City of Portland, Maine – Building or Use Permit Application 389 Congress Street, 04101, Tel: (207) 874-8703, FAX: 874-8716

Location of Construction: 42 Haywood St		Owner: Hidreth & White		Phone:		Permit No: 970298	
Owner Address:		Lessee/Buyer's Name:		Phone:		Business Name:	
Contractor Name: Hidreth & White		Address: P.O. Box 8433 Portland, ME 04104		Phone: 772-0657		<div style="border: 2px solid black; padding: 5px; text-align: center;"> PERMIT ISSUED APR - 9 1997 CITY OF PORTLAND </div>	
Past Use: 1-fam		Proposed Use: Same		COST OF WORK: \$ 1,500.00 FIRE DEPT. <input type="checkbox"/> Approved <input type="checkbox"/> Denied Signature:		PERMIT FEE: \$ 30.00 INSPECTION: U Use Group: R3 Type: 55 Signature: [Signature]	
Proposed Project Description: Construct Deck (12 x 18)				PEDESTRIAN ACTIVITIES DISTRICT (P.A.D.) Action: <input type="checkbox"/> Approved <input type="checkbox"/> Approved with Conditions <input type="checkbox"/> Denied Signature: _____ Date: _____			
Permit Taken By: Mary Cresik		Date Applied For: 04 April 1997

CHECK-LIST AGAINST ZONING ORDINANCE

BUILDING PERMIT REPORT

1/2 HAYWOOD ST

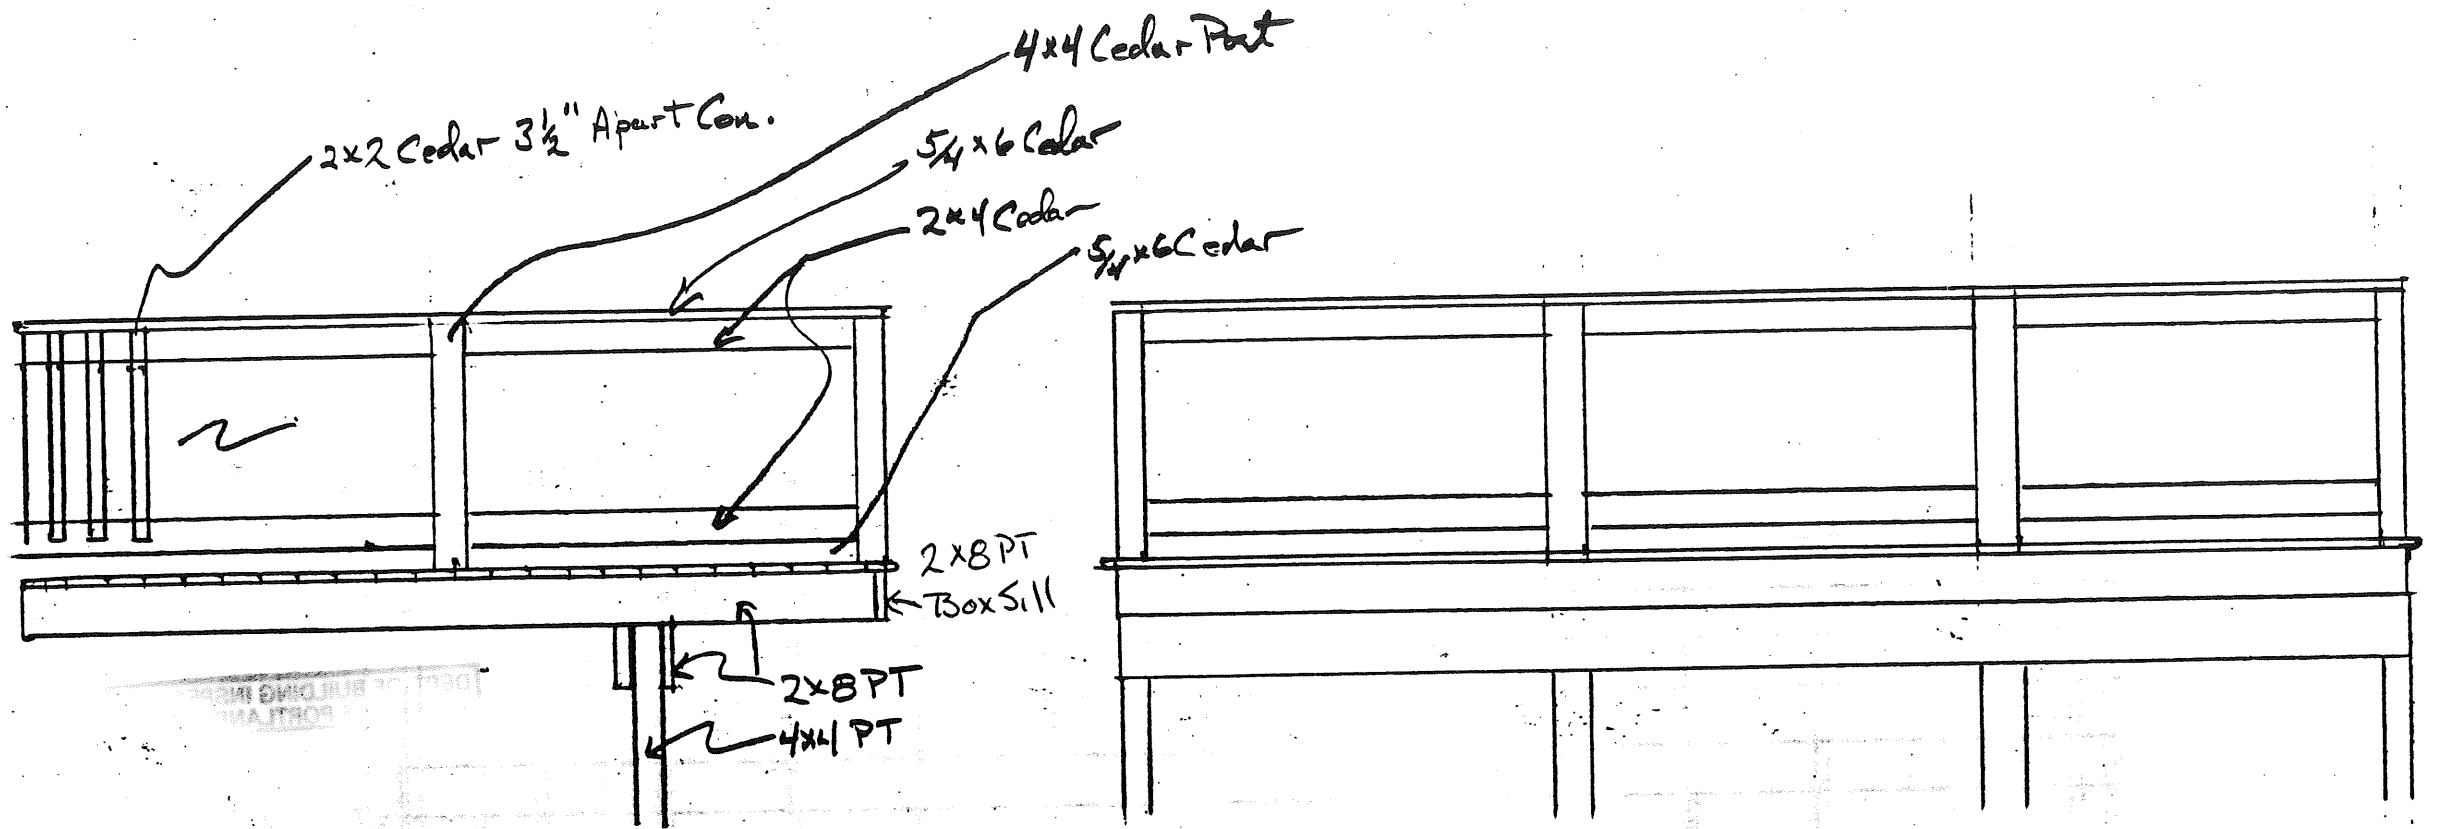
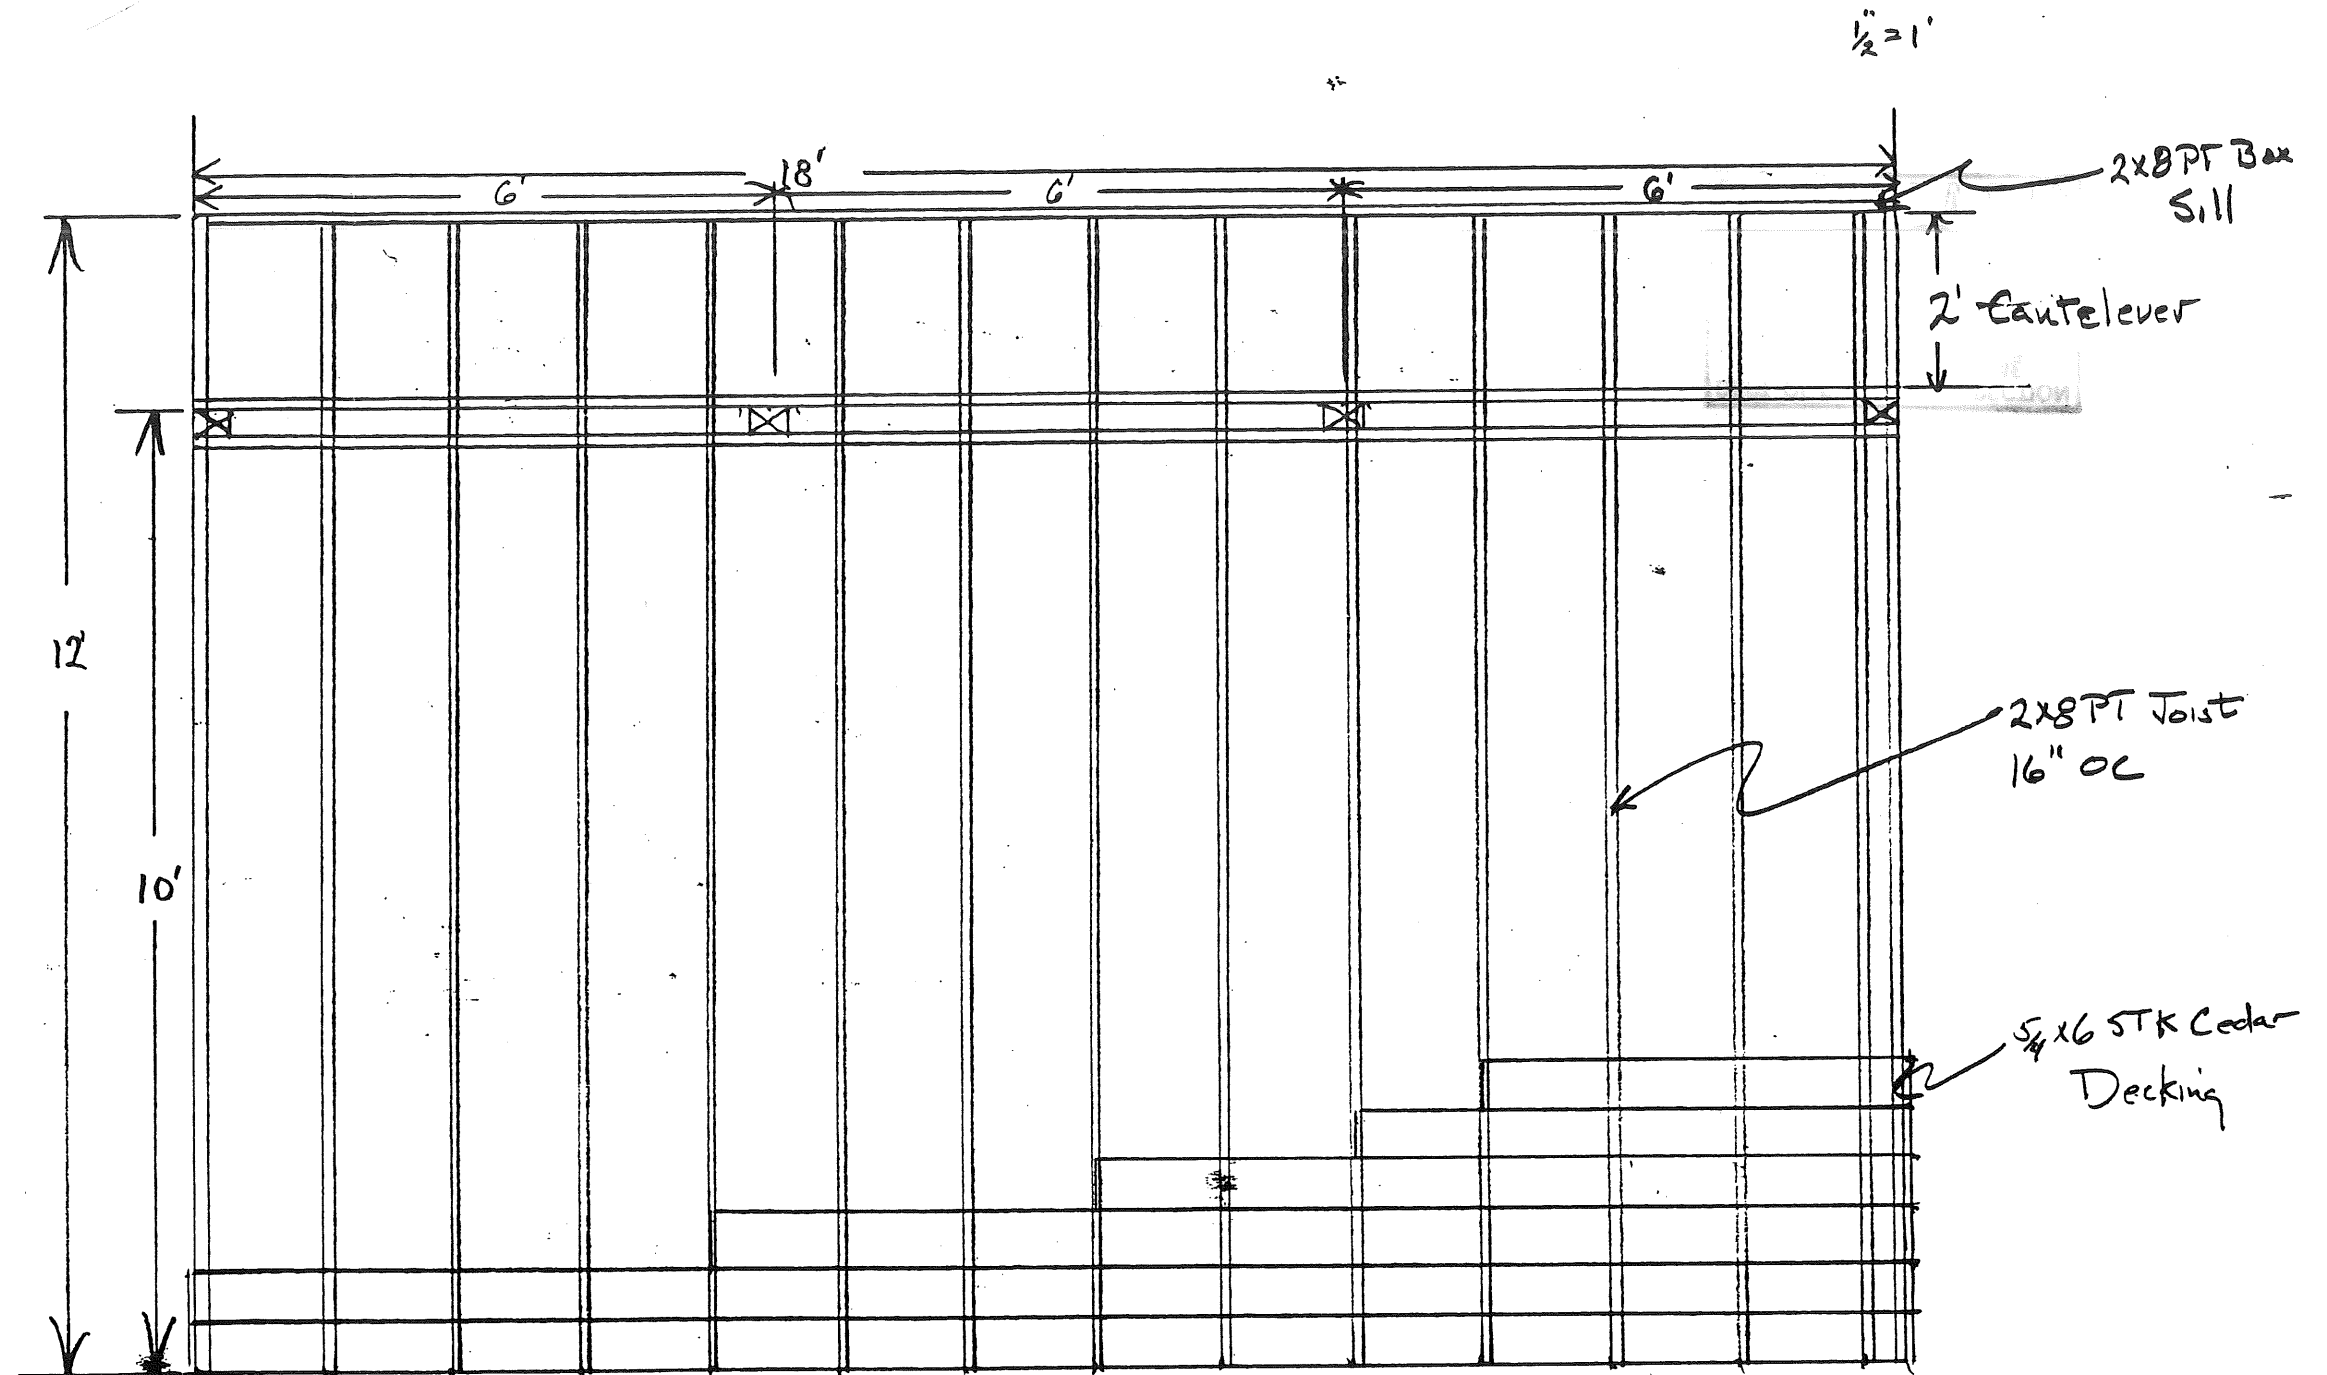
ok Rear Yard - 25' reg - 24' 6" shown } NOTE: 14-425 Allows A sill to project into ANY required yard a distance Not more than two feet

note: representation in the
 per phone conversation with
 Dan White is ~~not~~ correct
 2 feet - The property
 we would be having
 but should be having
 to show. ~~the~~
 cgr. 1/4/97

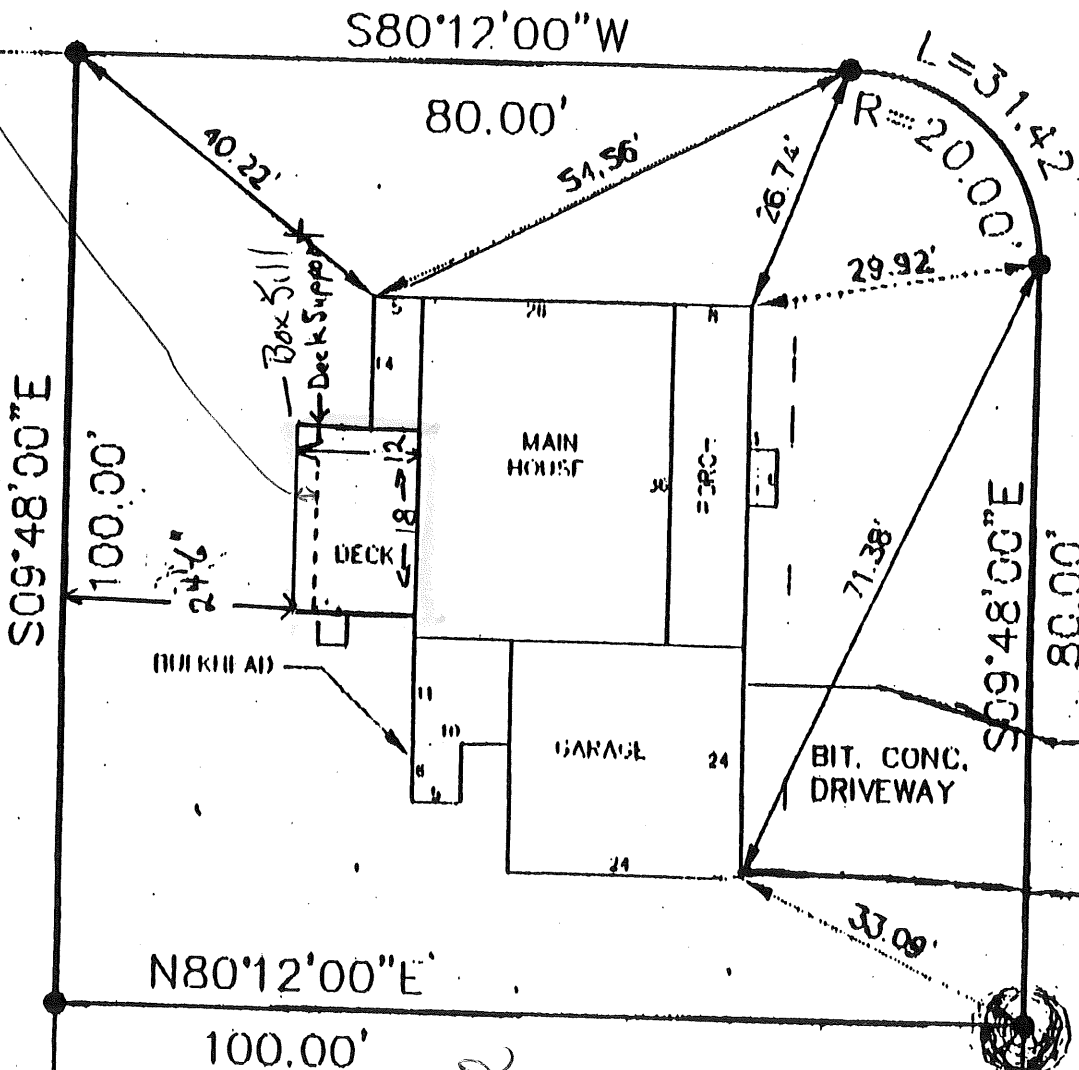
(14-425)
 PEAR
